Hearings Panel MINUTES ATTACHMENTS

Date: Monday 11 April 2022
Time: 9am
Venue: Major Cycleway Route Connections and Speed Review,
Via Audio/Visual link

Cycleway connection projects - central city Worcester Street and Antigua Street north of the footbridge

Antigua Street cycleway connection

Antigua Street Cycleway

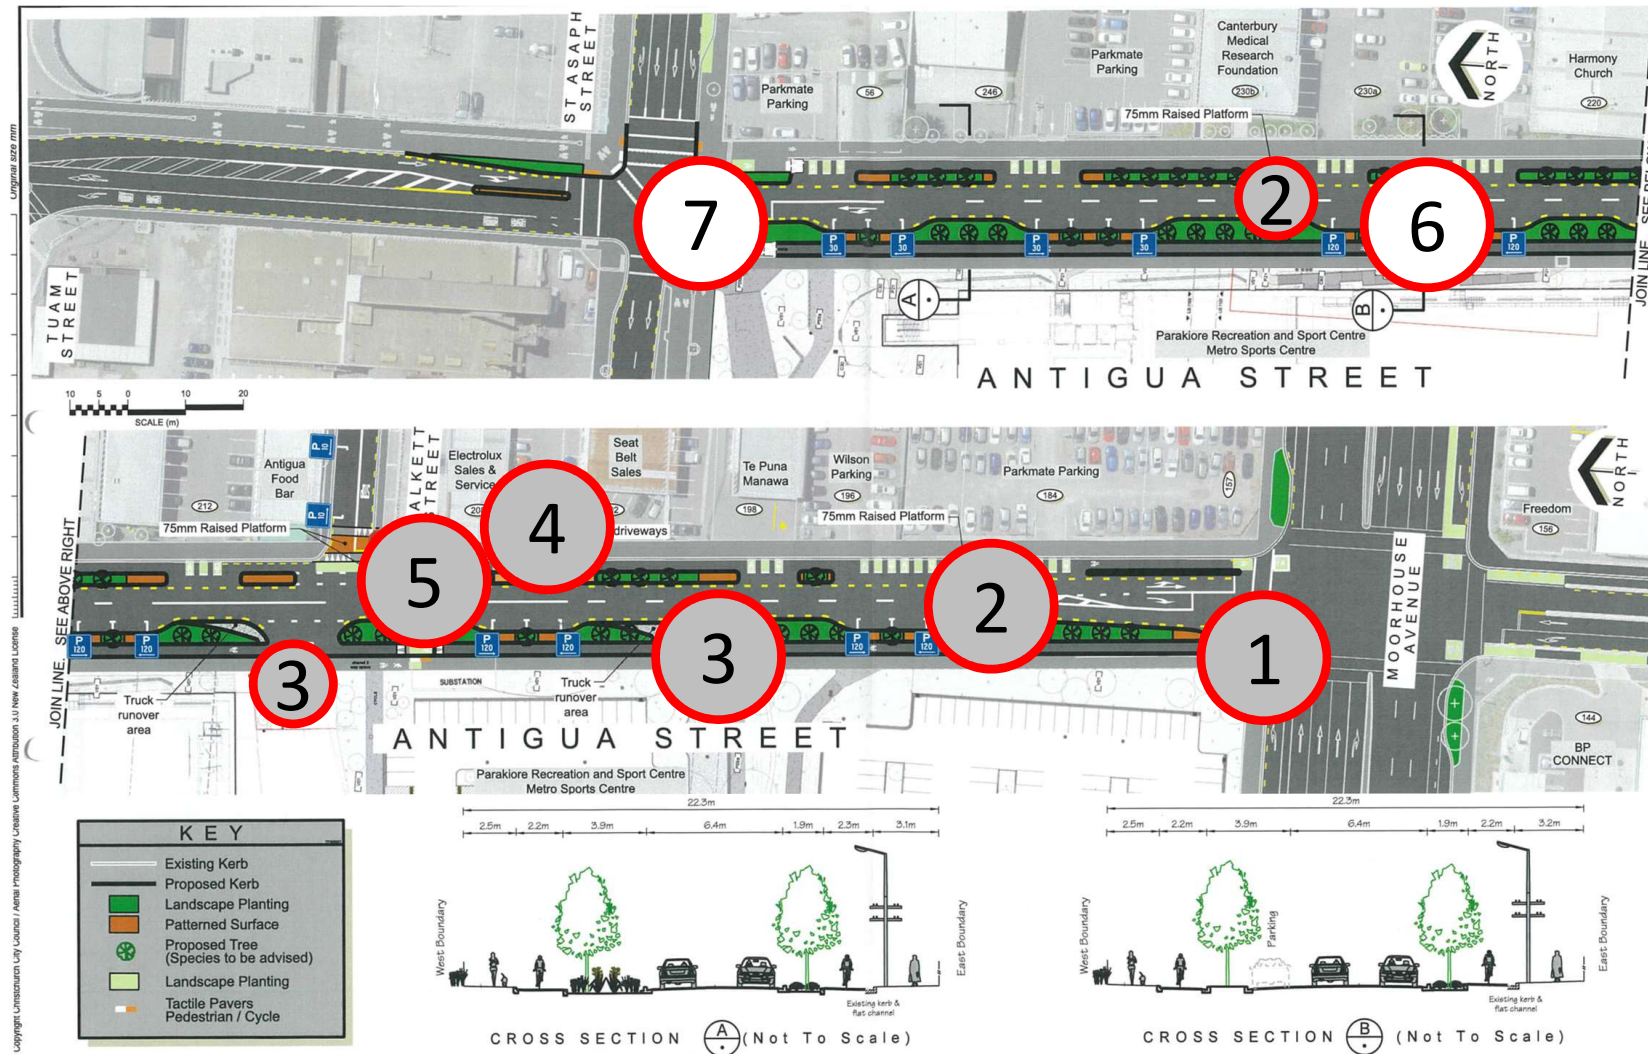
- 3: Entrances to Parakiore
 - Clear signage for right-of-way
 - Pedestrians first, cyclists second, drivers third
 - Change give-way signs to stop signs
 - Helps to make it clear that drivers are not the dominant roadway user
 - Improved visibility of cyclists and pedestrians for turning drivers
 - Ensure parked vehicles, plants, or trees at entrances don't obscure cyclists and pedestrians
 - Further speed reduction for drivers around the entrance may help improve visibility
 - Speed bump for drivers turning into Parakiore
 - We need more trees in the CBD, so other traffic calming measures should be employed before reducing planned greenery
- Where is the bike entrance and bike parking for Parakiore?
 - Clear signs and pavement markings linking the cycleway to bike-parking infrastructure at Parakiore
 - How do southbound cyclist get to the entrance and bike parking for Parakiore?

7

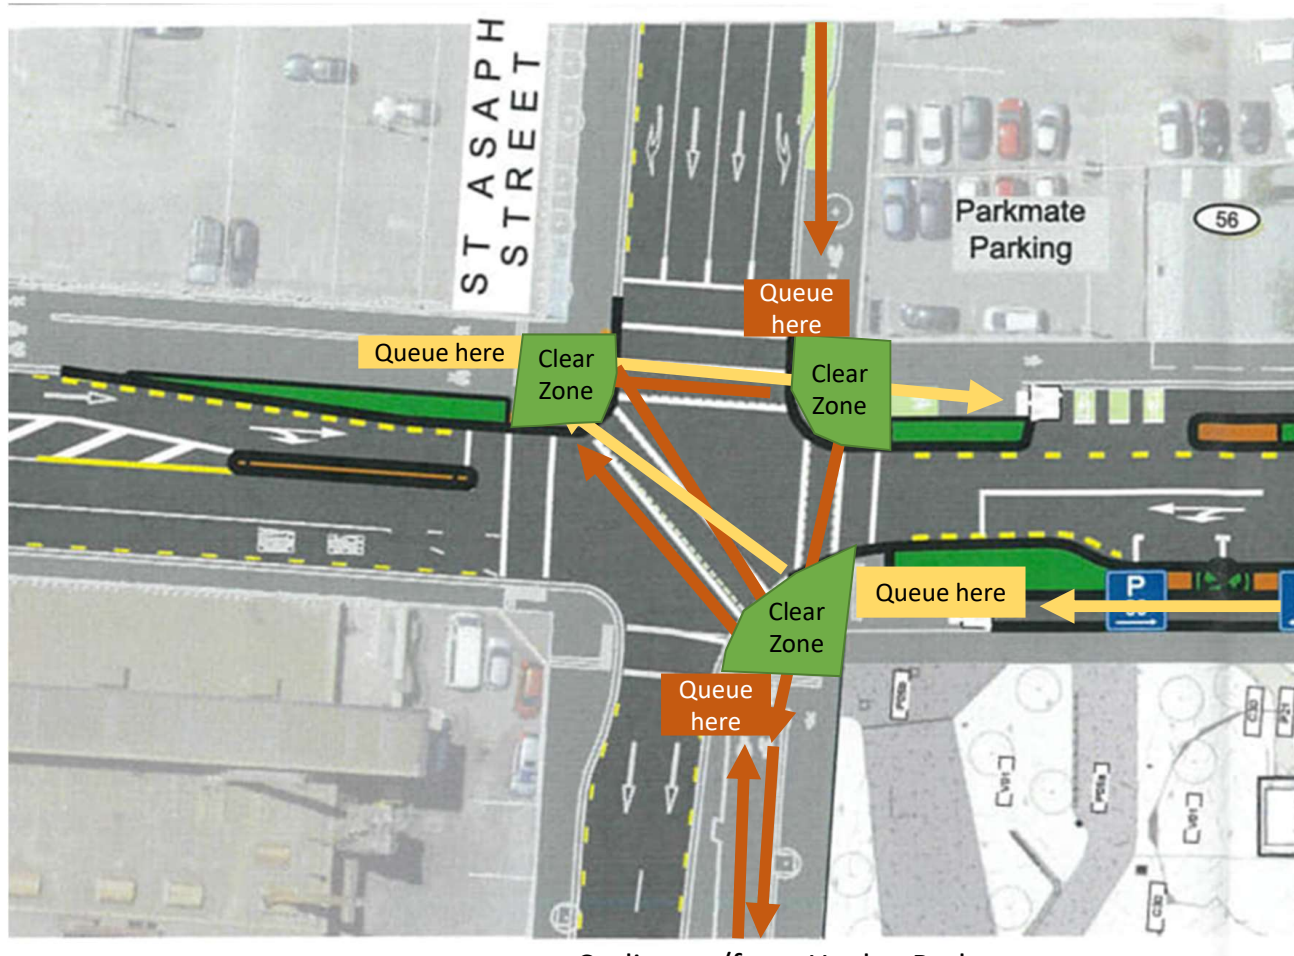
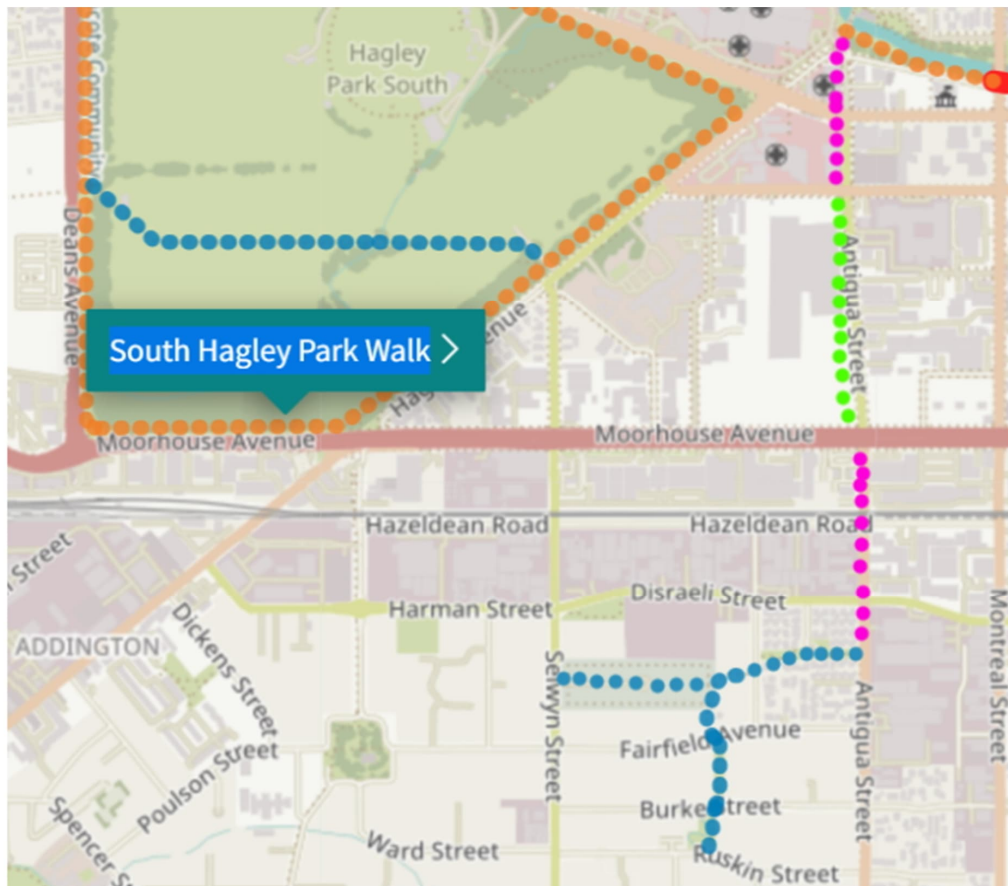
- 6: Signage for drivers parking along Antigua St.
 - Clear signage for right-of-way
 - Drivers crossing cycleway from their parked cars should yield to cyclists in cycleway
- 7: Link between St. Asaph Cycleway and Antigua Cycleway
 - A: Expand space for cyclists northeast, southeast, and southwest corners of intersection to allow more space for through-going and turning cyclists
 - Currently they are all too narrow and create unsafe bottlenecks
 - Remove some planting at SW corner to allow safe space for northbound cyclists to queue
 - Currently, queueing northbound cyclists are in the way of westbound cyclists from St. Asaph St.
 - This is a complex and important intersection of cycling infrastructure
 - Model traffic patterns and flows with the same level of consideration as driving infrastructure
 - There are similar issues at the Antigua & Tuam Street intersection as well!

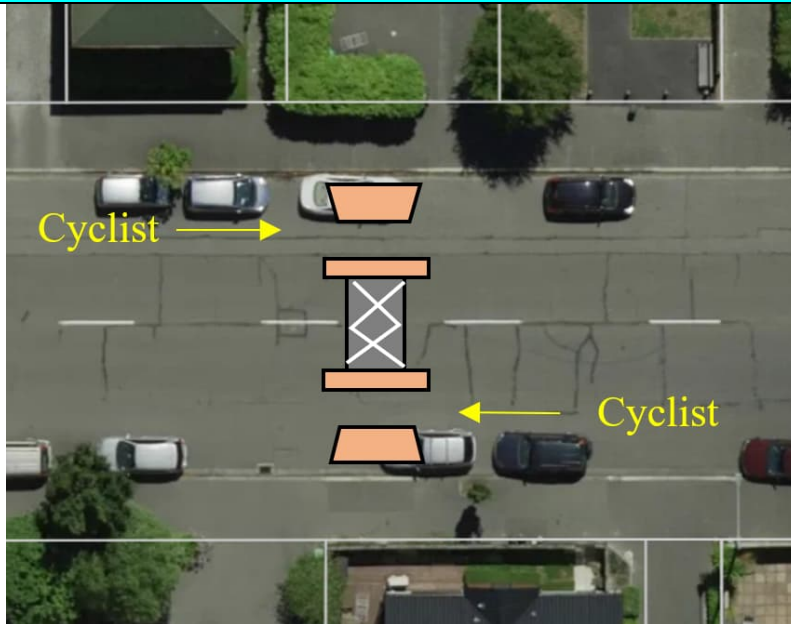
13	Hearing 14.04.22 Jimmy Chen	Consider to install more narrow traffic-calming device along this section?	<p>Potentially other traffic calming devices could be considered such as a road narrowing with hump and cycle bypass (see image below). This would have limited benefit over speed humps with the exception of allowing cyclists to bypass the hump. The central narrowing would need to be one-way hence opposing vehicles would need to give-way to each other. This was not progressed as it is a higher cost option and results in increased loss of on-street parking. A single isolated narrowing would also be out of context with the rest of the wide, uninterrupted street hence presents a greater safety risk to general traffic than a speed hump. Placement of these relative to driveways and the impact on property access is also more challenging given the frequency of access ways along the street.</p>
